**TRAVIS AFB
CALIFORNIA**

**North/East/West Industrial Operable Unit
Soil, Sediment, and Surface Water
Record of Decision**

FINAL

SUBJECT: Final North, East, and West Industrial Operable Unit (NEWIOU) Soil, Sediment, and Surface Water Record of Decision (ROD)

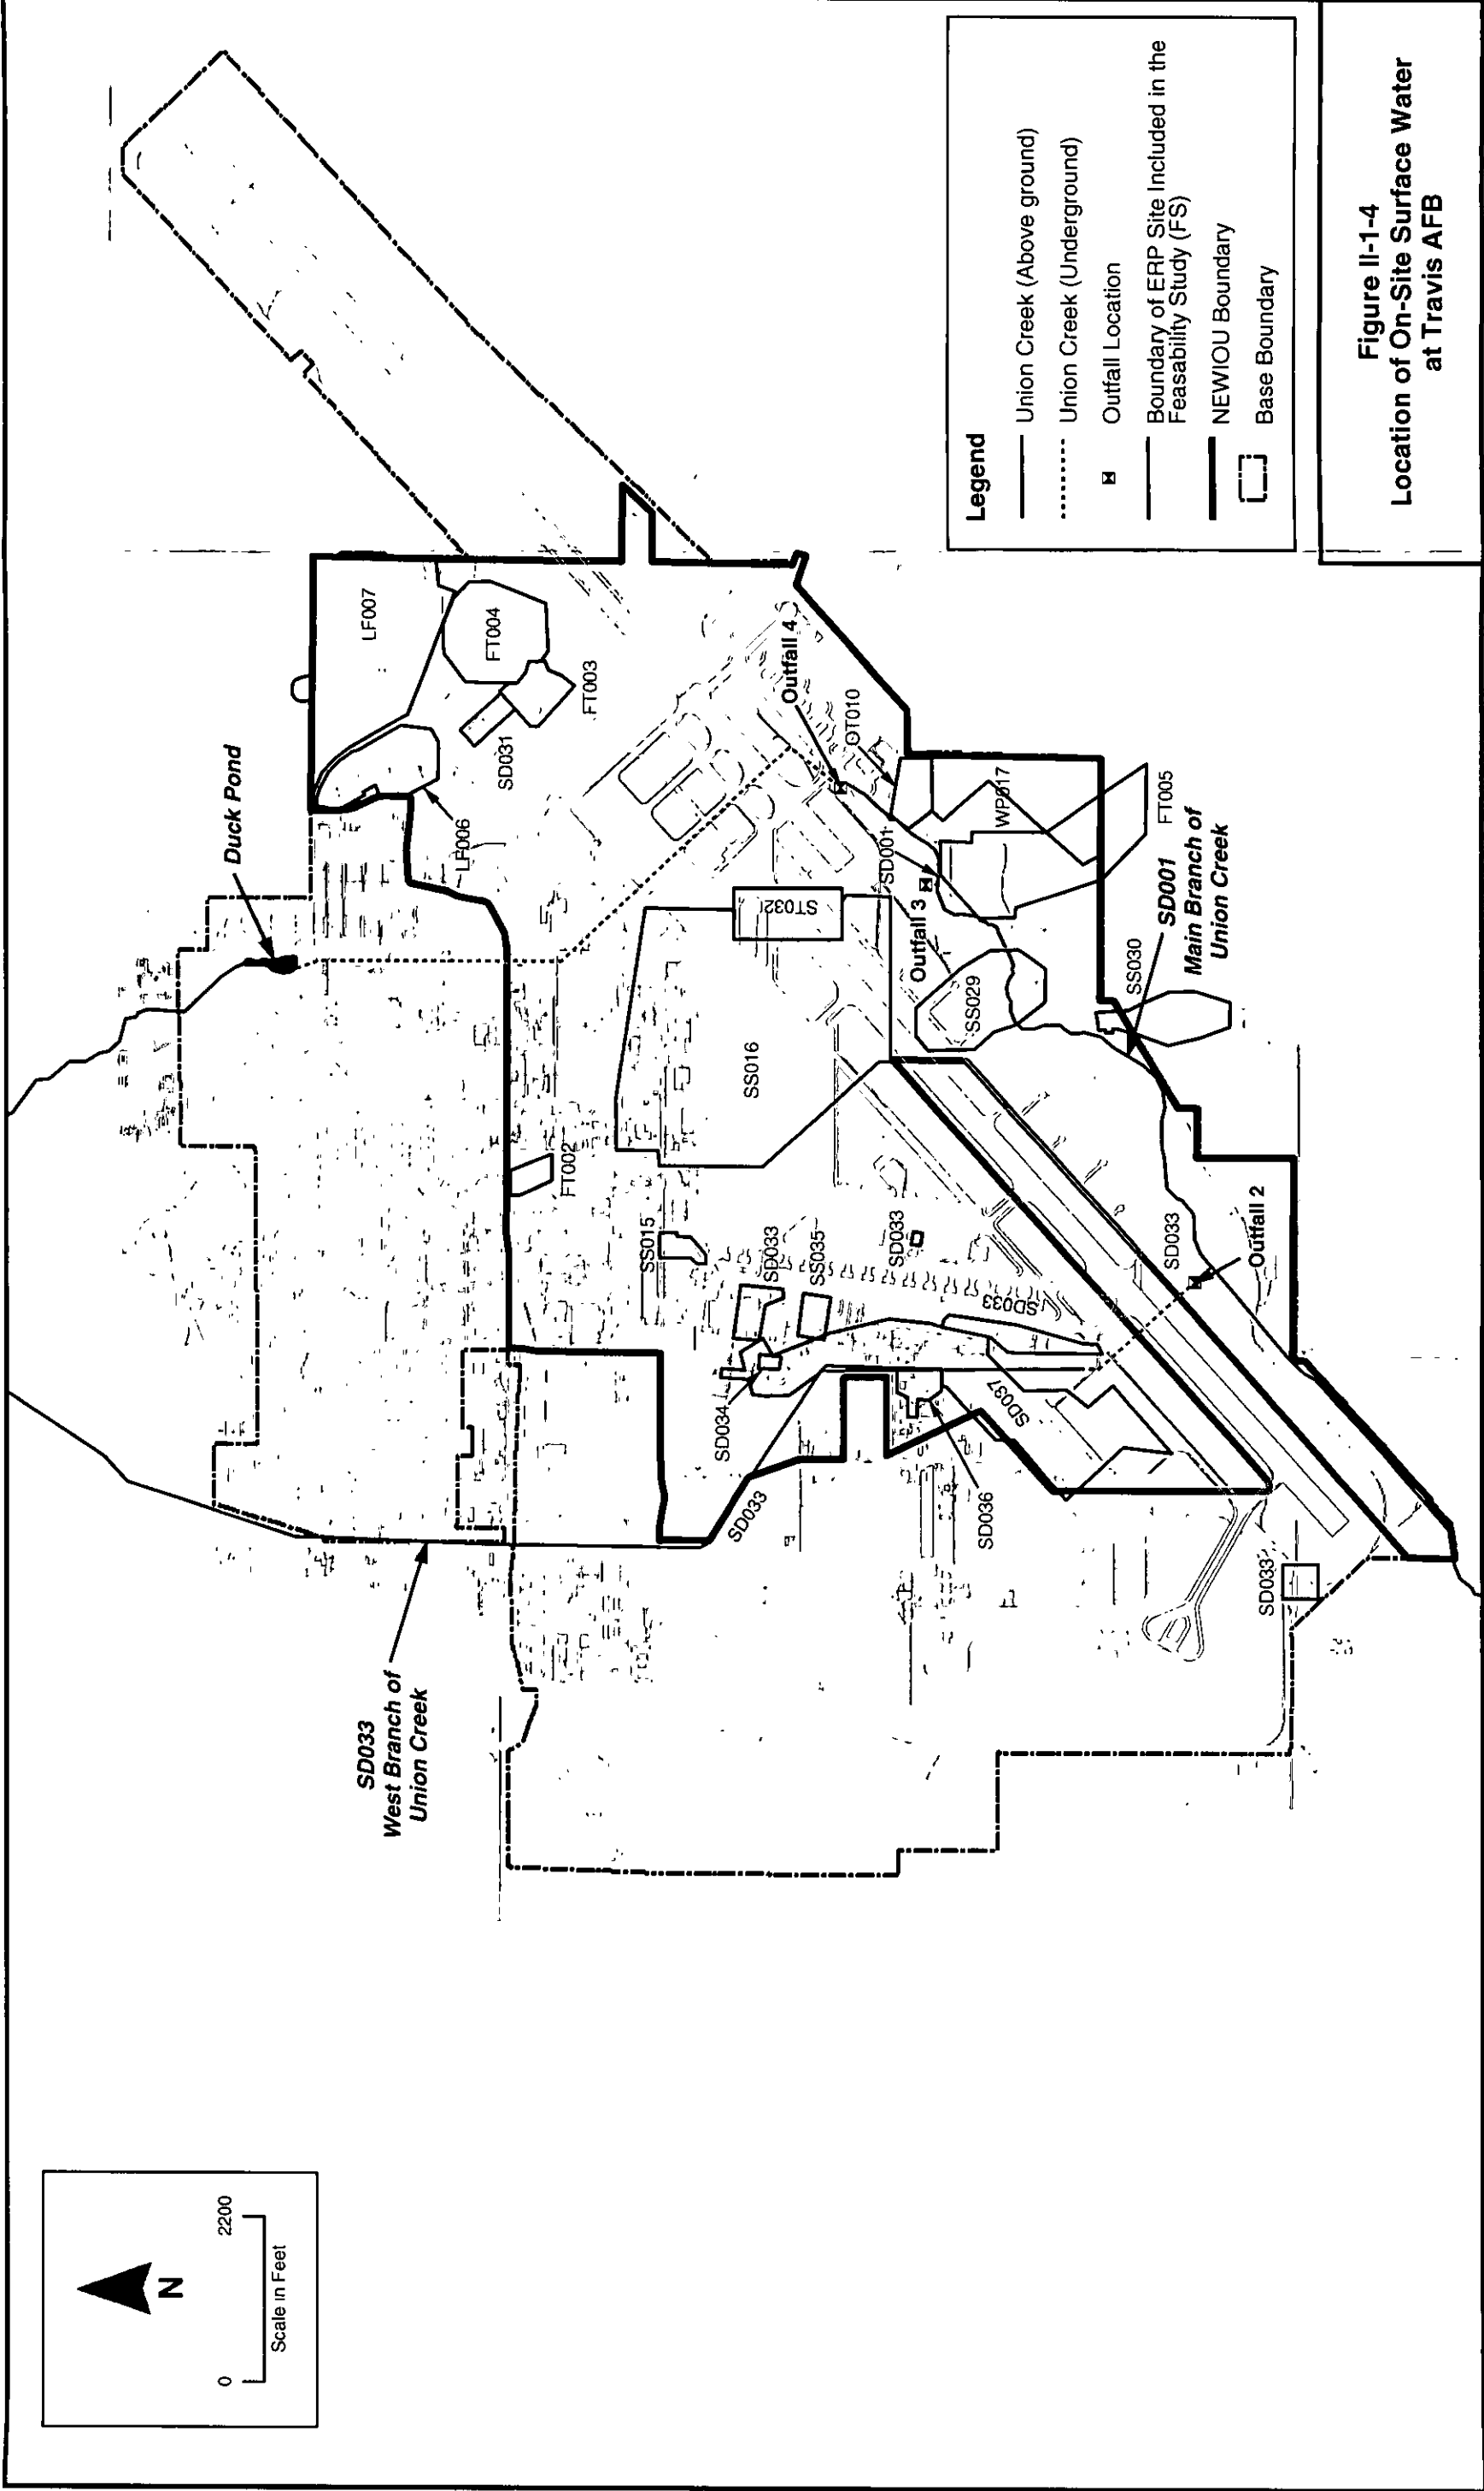
2. Section 1.5, Surface Water, Page II-1-14 and Figure II-1-4: The text description of the West Branch of Union Creek does not appear to agree with its depiction on the figure. The text states, "This channel flows south to the northeastern corner of the NEWIOU. The channels forms the boundary between the WIOU and the EIOU and parallels Ragsdale Street for

about 4,000 feet." None of these three statements appears to agree with the location and alignment of the West Branch of Union Creek as shown on Figure II-1-4. The Creek appears to flow south to the middle of the western boundary of the NEWIOU, form the boundary between the WIOU and the WABOU, and parallel Ragsdale Street for less than 2,000 feet. Please correct the text and/or the figure to resolve these discrepancies.

3. **Figure I-1-1, Figure II-1-4, and Figure II-5-2:** The boundary between the WIOU and the WABOU is very different on Figure II-1-4 than on Figure I-1-1 and the alignment of the creek is very different than on Figure II-5-2. Please resolve the discrepancies in boundaries and stream alignment as depicted on these three figures.

RESPONSE: The West and Main Branches of Union Creek will be updated on Figure II-1-4 to match the more recent Figure II-5-2. Paragraph 3 of Section 1.5 will be revised as follows: "The West Branch of Union Creek flows south and enters the northwestern border of Travis AFB east of the David Grant Medical Center in an excavated channel. This channel flows south to the northeastern corner of the WABOU and continues southeast along the western side of the WIOU until flow in the channel is directed to a culvert under the runway and discharges to the main channel of Union Creek at Outfall II. From Outfall II, Union Creek flows southwest and discharges into Hill Slough, a wetland located 1.6 miles from the Base boundary. Surface water from Hill Slough flows into Suisun Marsh."

RESPONSE: The alignment of the creek will be made to agree with Figure II-5-2. On Figure II-5-2, the individual Operable Unit boundaries (not the NEWIOU boundary) are shown in gray (like the background features) to keep the emphasis on the creek (shown in blue) and the drainage basin boundaries (shown in red).

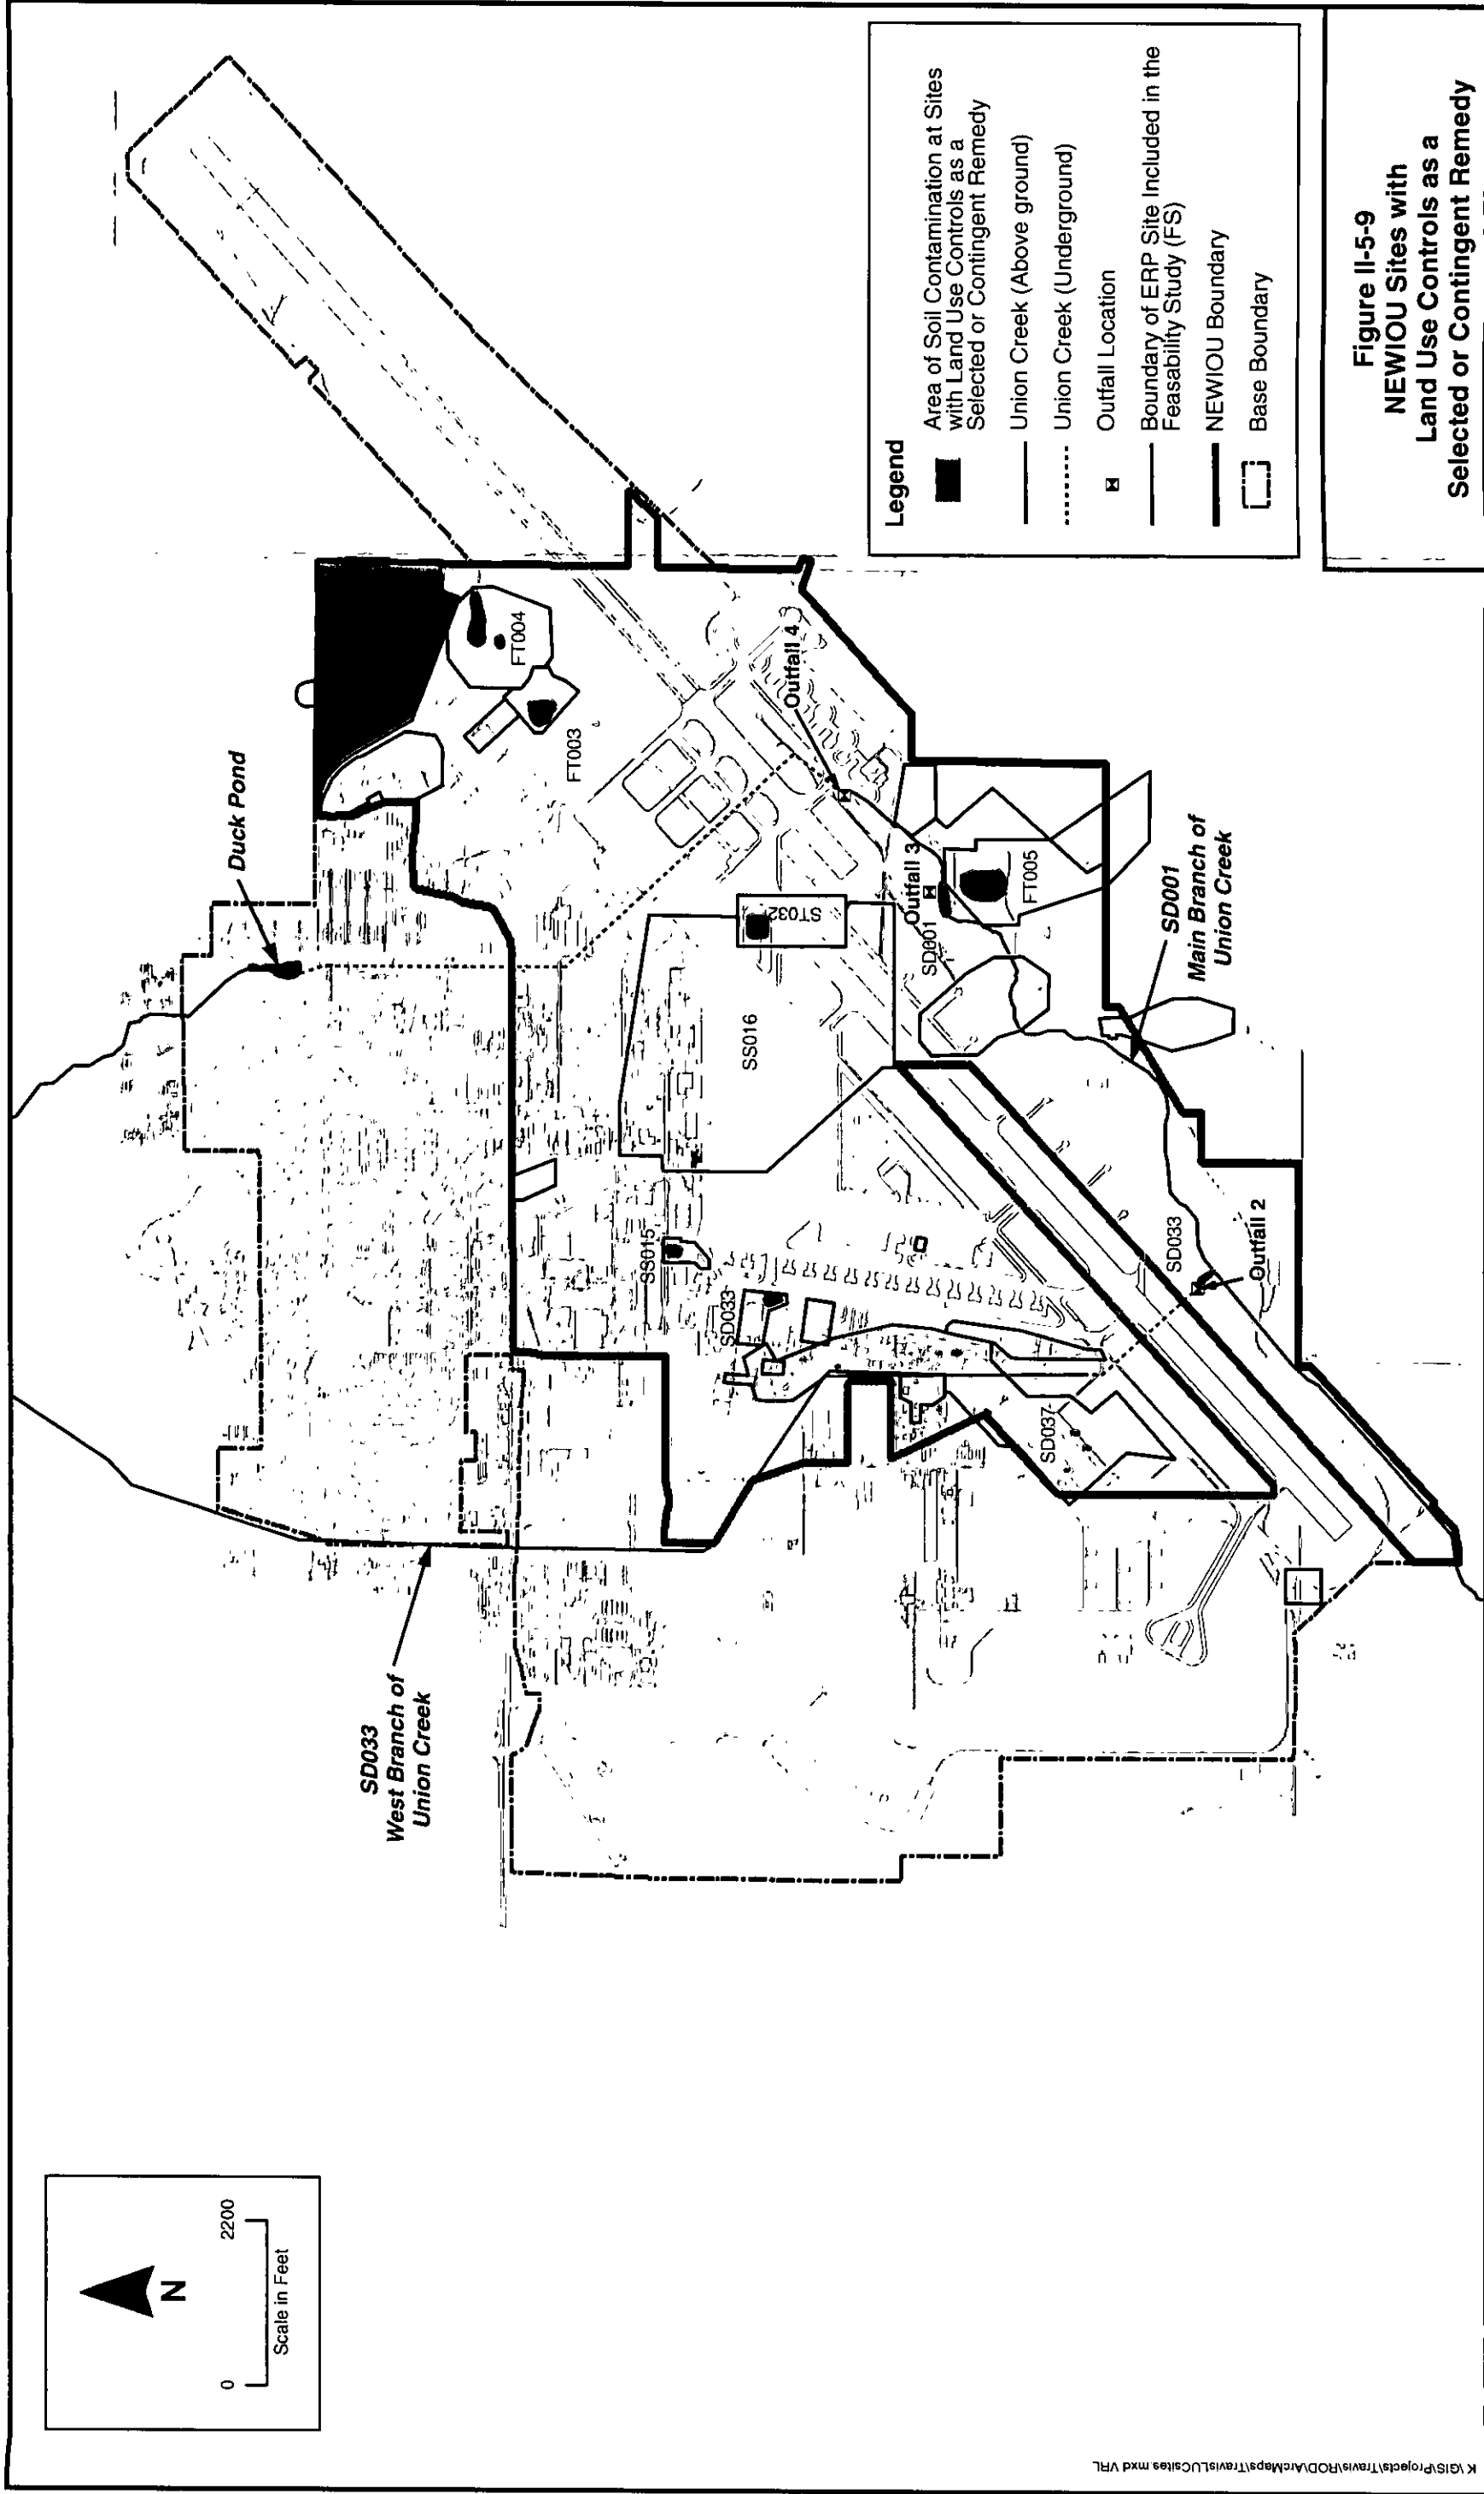
12. Section 5.4 Land Use Controls, page II-5-66, top of page, incomplete bullet, please replace the last sentence with the following: "After the remediation is complete, the Base General Plan will be modified to include a basewide map similar to Figure II-5-9 depicting where land use controls are in effect, and also site-specific maps showing in more detail the location of the LUCs within each site. The Air Force will notify the regulatory agencies when these changes are made and will send copies of the maps to the agencies. The Air Force also agrees that the regulatory agencies will have access to the General Plan."

RESPONSE: We propose slightly different language, as follows: "After remediation action is complete, the Base General Plan will be updated to include a basewide map, similar to Figure II-5-9, depicting where land use controls are in effect and site-specific maps showing, in more detail, the location of the LUCs within each site. The Air Force will notify the regulatory agencies when these changes are made and will send copies of the maps to the agencies. The Air Force also agrees to provide the regulatory agencies with electronic access to view the Base General Plan during regulatory visits to Travis AFB."
